Upper South Creek Advanced Water Recycling Centre

Amendment Report

March 2022

Sydney
WATER

Figure 4-1 The Northern Road realignment

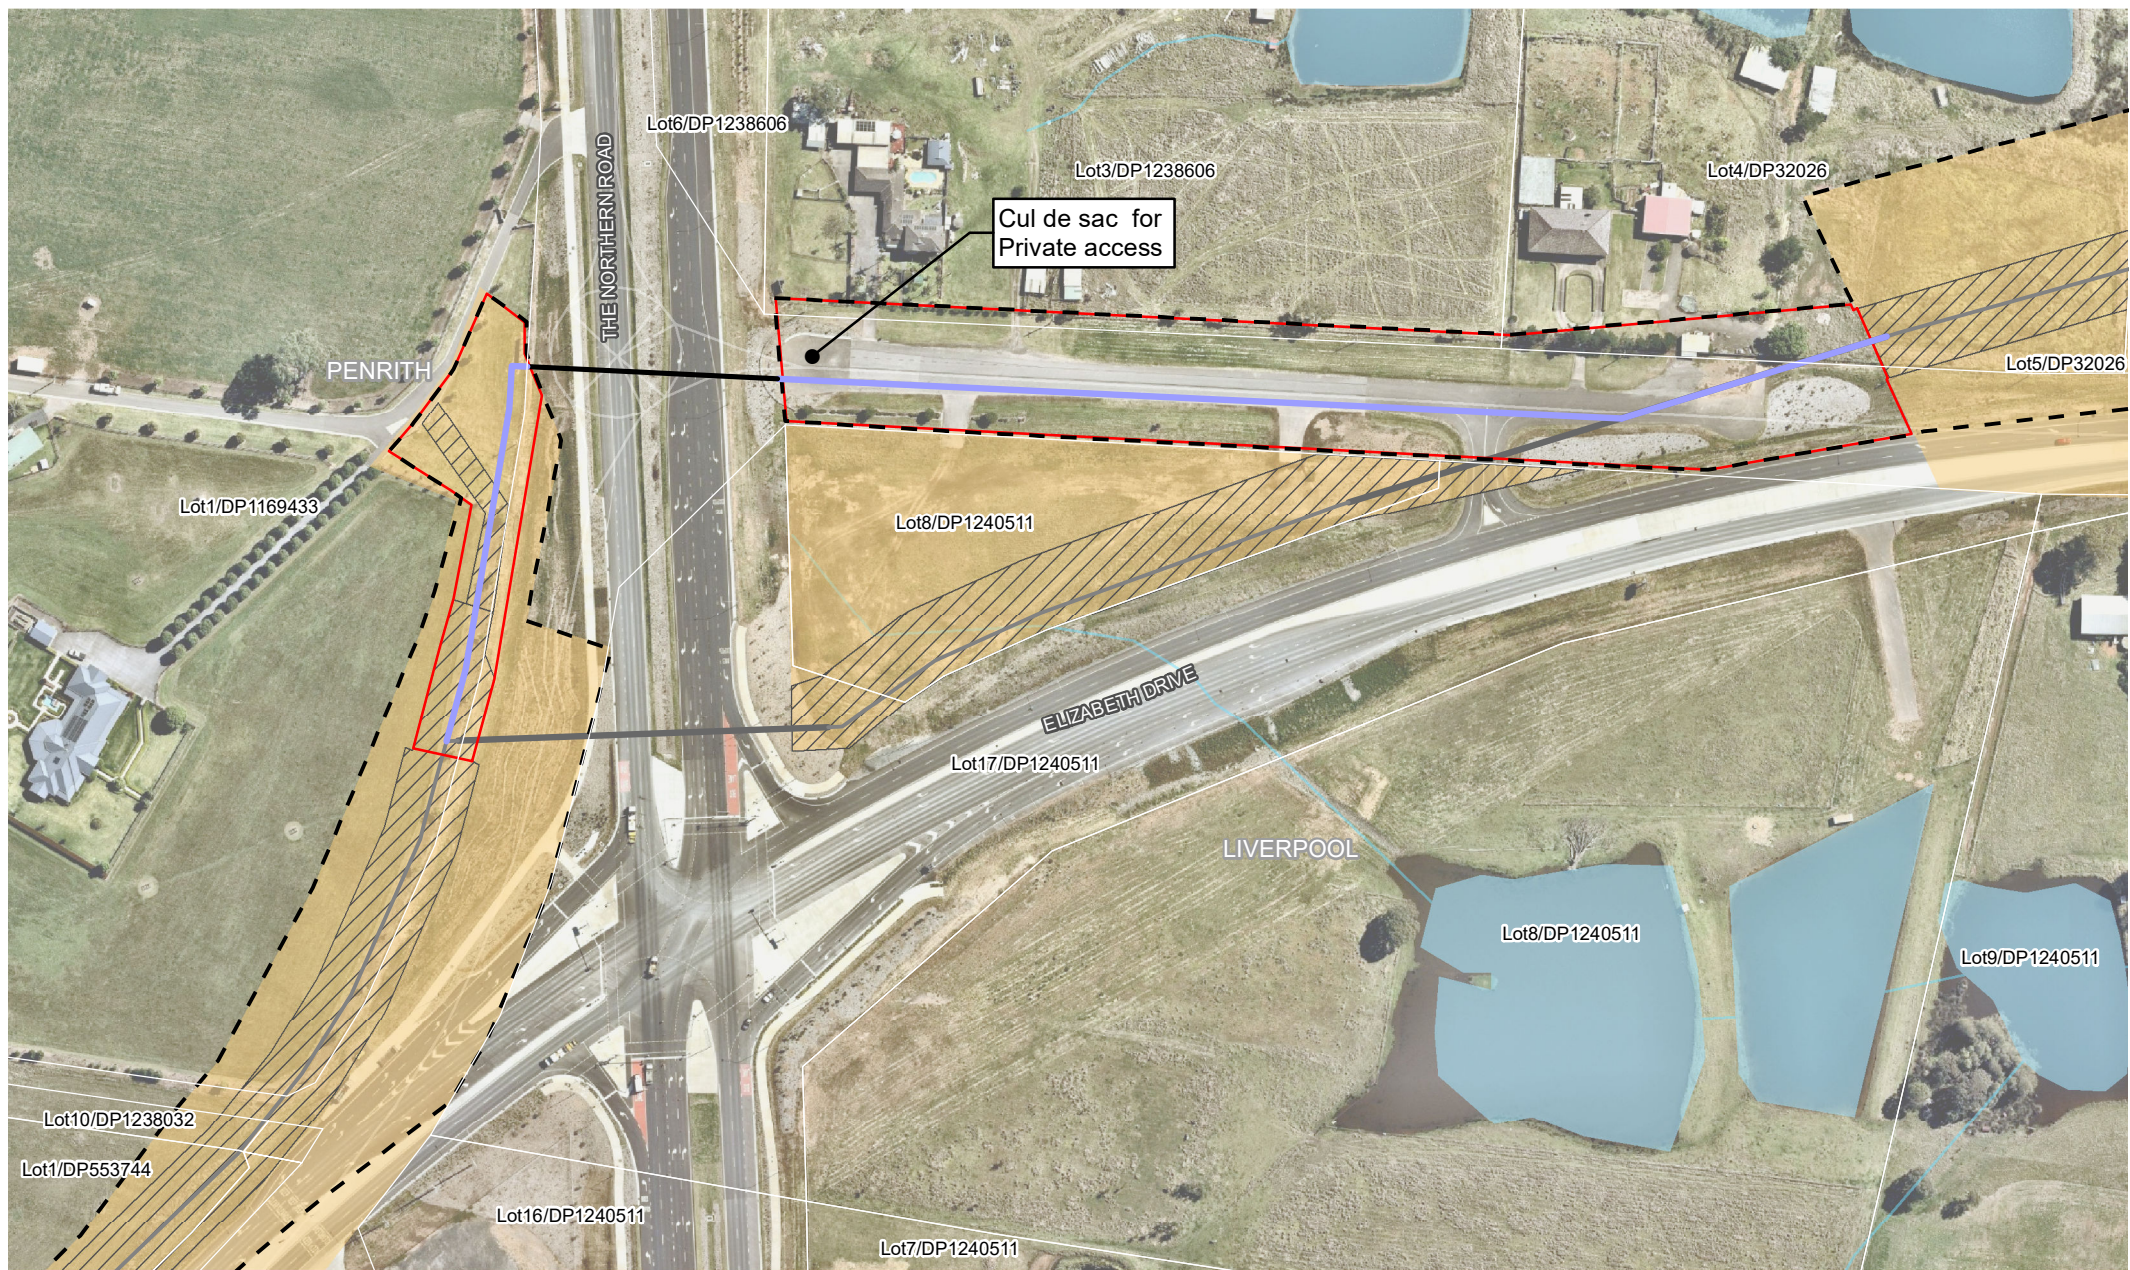
The area where alignment changes are proposed is in the Penrith City local government area (LGA) and is shown in Figure 4-17d of the EIS and in Figure 4-1 of this report. In this location, as described in the EIS, the treated water pipeline runs along the northern side of Elizabeth Drive, outside the current road verge, in an area that will be adjacent to Elizabeth Drive once it is widened. The treated water pipeline then crosses under Elizabeth Drive and under The Northern Road, and continues south along The Northern Road towards Park Road.

Figure 4-1 shows the proposed realignment of the treated water pipeline around The Northern Road. Figure 4-17 in Appendix A provides an updated construction area of the entire project as part of the project description.

Figure 4-1 also shows changes to the construction footprint associated with the amendment. As described in Chapter 4 of the EIS, construction will occur within the impact area. The location of the impact area has changed to follow the pipeline realignment.

Figure 4-3 Kemps Creek realignment

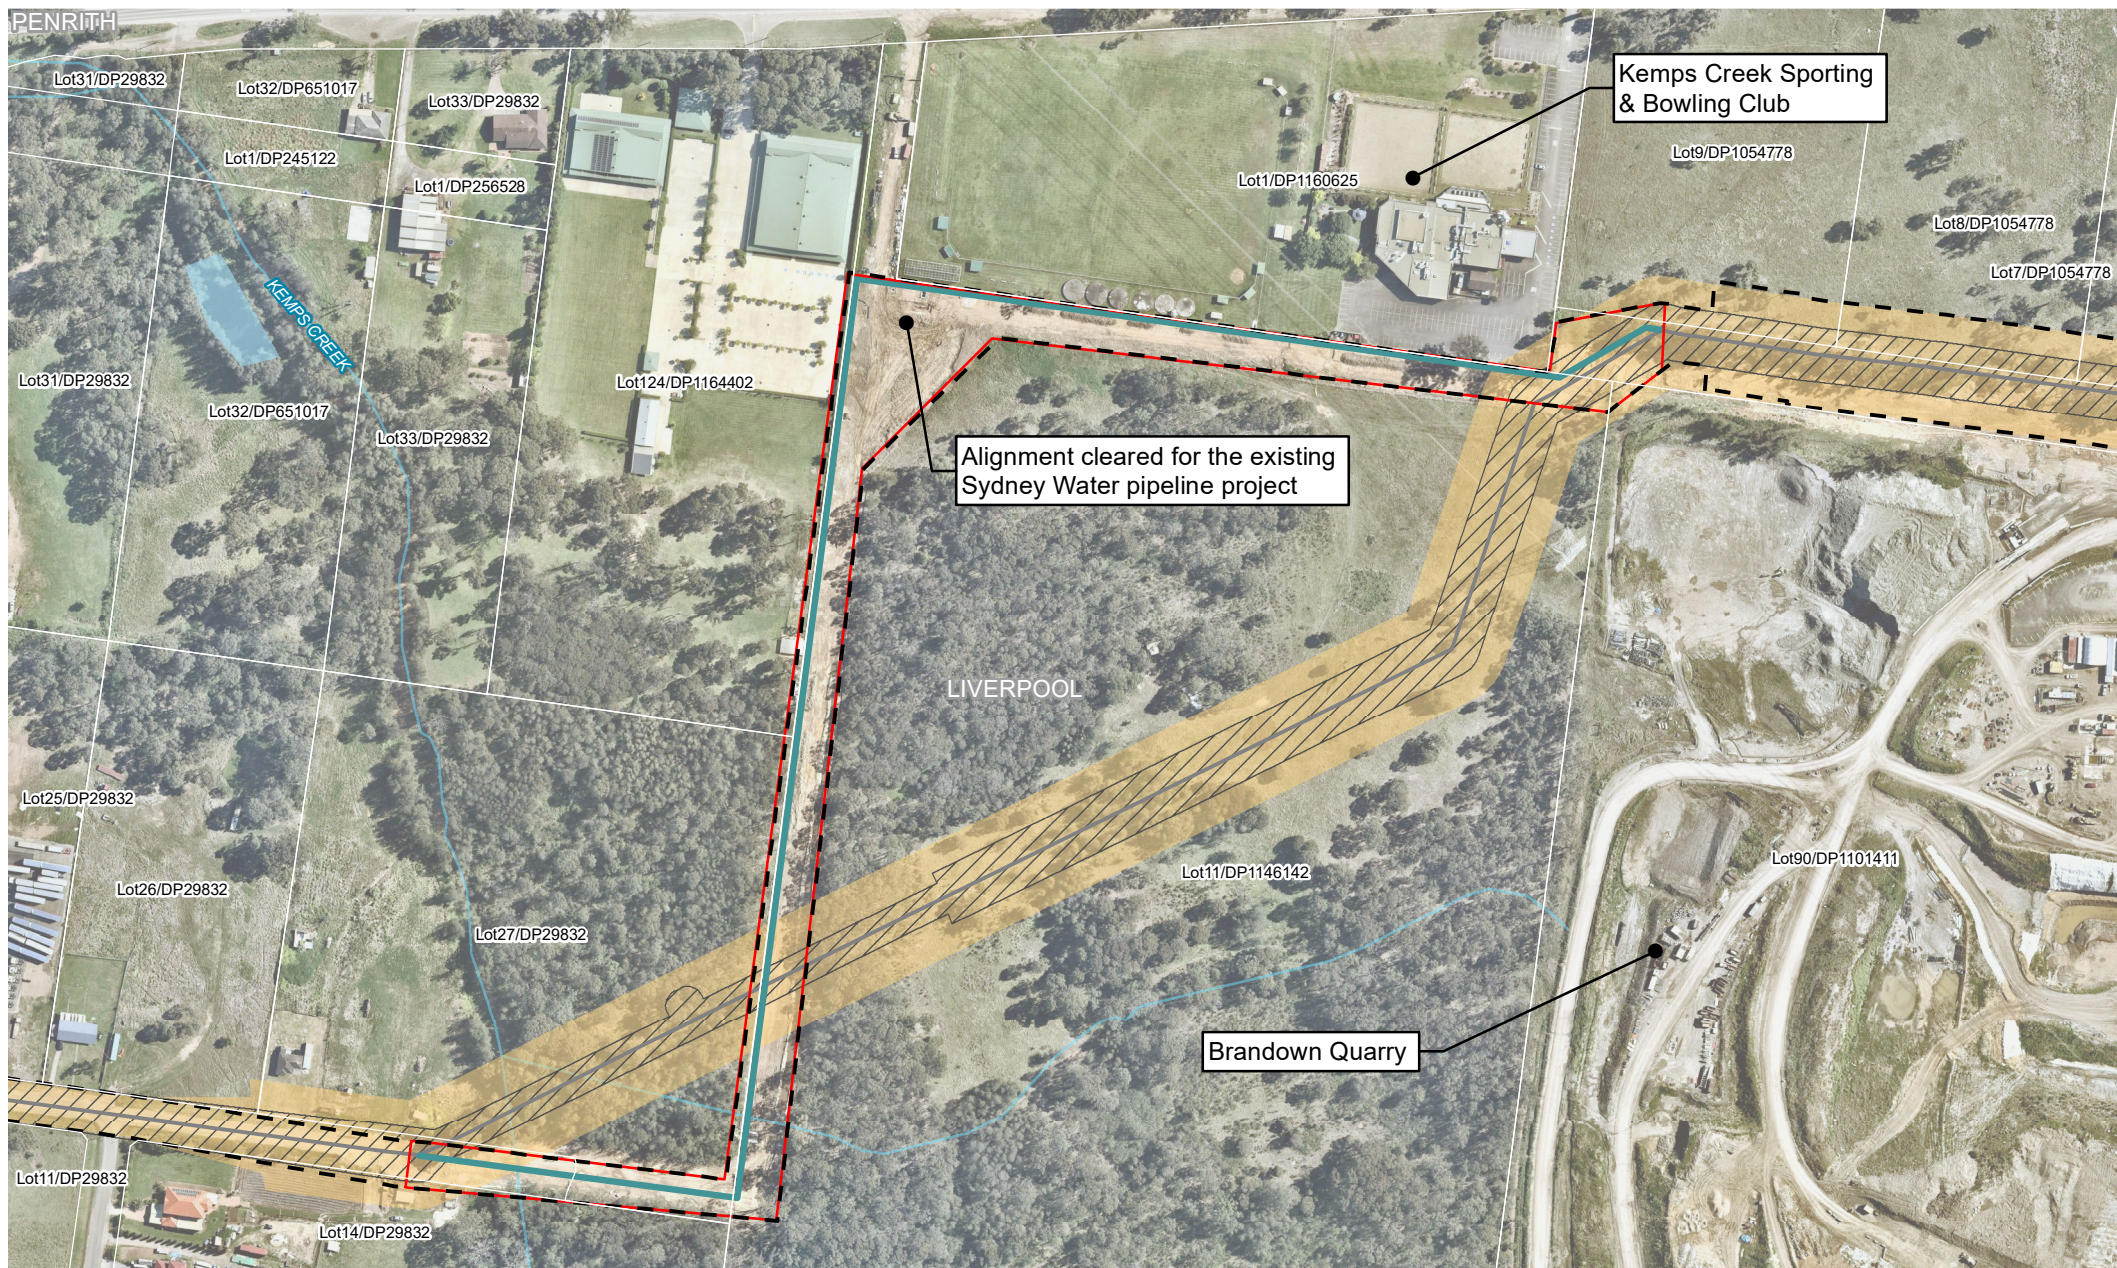
The area where alignment changes are proposed is in the Liverpool City LGA and is shown in Figure 4-17h of the EIS and in Figure 4-3 of this report. The brine pipeline runs from the end of Cross Street and continues northeast across bushland then along the northern boundary of Brandown Quarry. The brine pipeline crosses Kemps Creek just east of Cross Street.

Figure 4-3 shows the proposed realignment of the treated water pipeline around Kemps Creek. Figure 4-17 in Appendix A provides an updated construction area of the entire project as part of the project description.

Figure 4-3 also shows changes to the construction footprint associated with the amendment. As described in Chapter 4 of the EIS, construction will occur within the impact area. The location of the impact area has changed to follow the pipeline realignment. The proposed amendment realigns the pipeline into an existing pipeline corridor, which minimises vegetation impacts. Construction of the pipeline across Kemps Creek will no longer require open trenching across the creek as described in the EIS. The brine pipeline will be installed through existing concrete casing pipes under Kemps Creek that have been built as part of the other Sydney Water pipeline project.

Figure 4-7 AWRC site boundary change

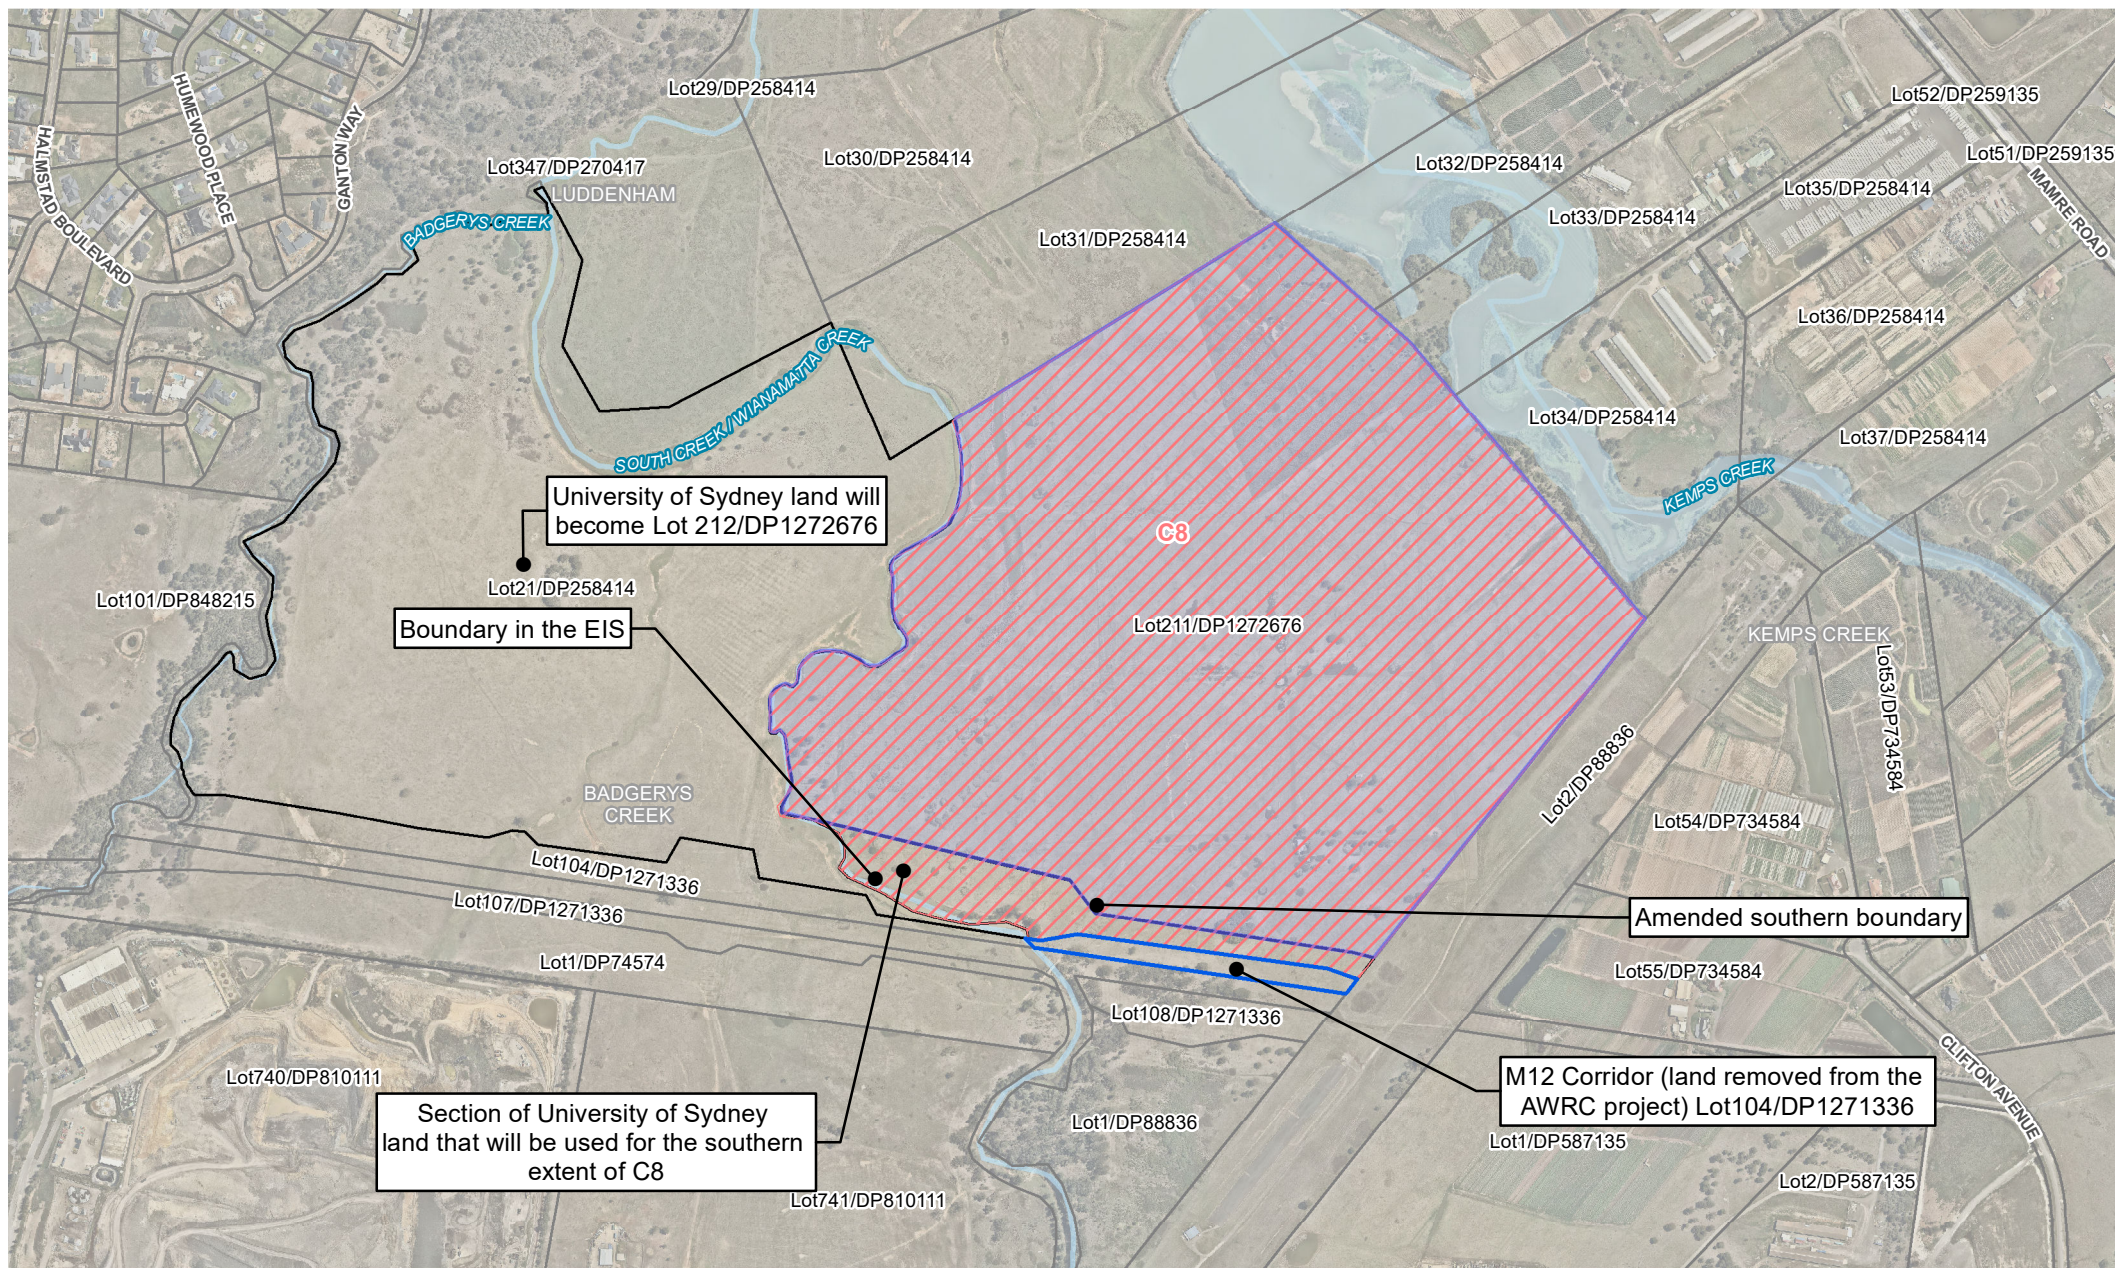
The AWRC site is in the Penrith LGA and is shown in Figure 4-1 of the EIS and Figure 4-7 of this report.

Figure 4-7 shows the proposed change to the AWRC site's southern boundary to align with the land purchased by Sydney Water for the AWRC. The land no longer part of the AWRC site includes:

As shown in Figure 4-7, the construction footprint for the AWRC site is slightly smaller as it will remain within the revised AWRC site boundary. A construction footprint has also been added for the South Creek release infrastructure where it is outside the AWRC site. As described in Chapter 4 of the EIS, construction will occur within the impact area. The proposed amendment does not require any changes to construction methodology described in Chapter 4 of the EIS, including construction techniques, construction schedule, construction hours and construction traffic and access.
